Corrigendum - 3 dated 01/06/2026 to CPC Tender No. BHEL/CPC/TLB/EPC AHP MRHS/27/014

Corrigendum - 3 dated 01/06/2026 to CPC Tender No. BHEL/CPC/TLB/EPC_AHP_MRHS/27/014 for the work of “EPC PACKAGE FOR ASH HANDLING SYSTEM PACKAGE AND MILL REJECT HANDLING SYSTEM AT 3X800MW, NLC TALABIRA THERMAL POWER PROJECT, JHARSUGUDA, ODISHA”.

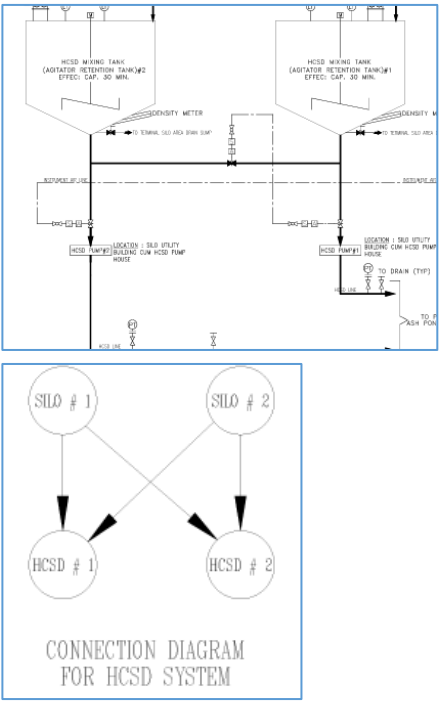
68	<u>Sl. No./Chapter:5</u> Broad Scope Matrix & Terminal points for EPC PKG-Ash Handling Plant & Mill Reject Handling System (Annexure-2)	<u>Remarks</u> 3. Necessary hook up linkage to the main plant (if required) shall be done by EPC-vendor.	Kindly elaborate on the requirement for hook up linkage to the main plant.	All necessary supply, services, works for integration of the system to main plant shall be in the scope of Bidder.

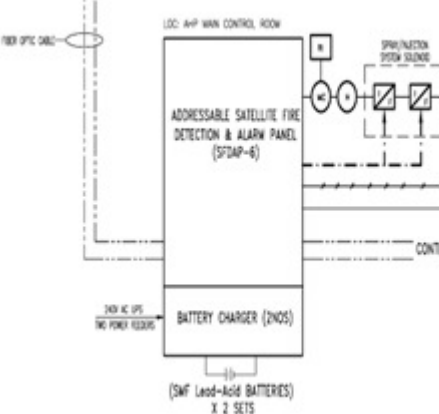
70	Sl. No./Chapter:14 Broad Scope Matrix & Terminal points for EPC PKG-Ash Handling Plant & Mill Reject Handling System (Annexure-2)	<u>Remarks</u> Sewerage network / system shall be developed for AHP buildings by Ash Handling Plant vendor. Network consists of underground piping connected to Collection/Lifting pits, all in Ash Handling Plant vendor scope.	Bidder will consider the sewerage collection/ lifting pit to be located within 5m from the respective ash handling building. Bidder's scope will be terminated upto those sewerage collection/ lifting pit from the respective ash handling facilities. Sewerage collection/ lifting pit and further transfer of sewerage will be in BHEL scope. Kindly confirm.	Entire sewerage system including network/connection, Collection pit shall be in the scope of Bidder
